Existing Kiosk Removals Associated with Link Proposal at Grays Inn Road (OS No 200)

**Subject:** Grays Inn Road, o/s 200 - 2017/3158/P, TfL response

## Grays Inn Road, o/s 200 2017/3158/P

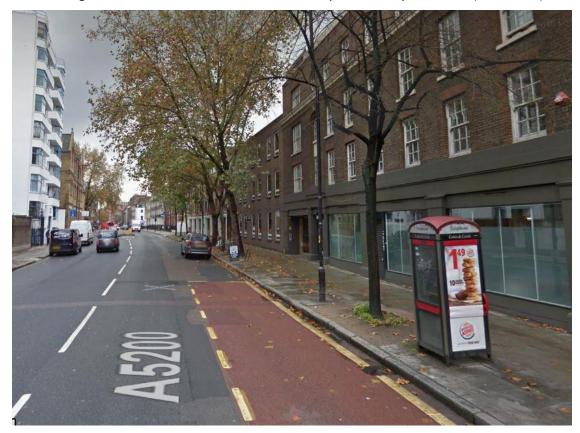
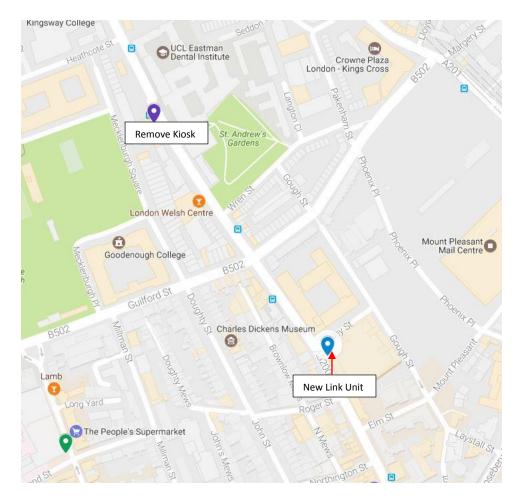
Firstly, the new BT Link unit would be directly adjacent to a taxi rank, as shown in the attached drawings. As a result application also requires comments by TfL Taxis. They have been forwarded details of the application and will respond directly.
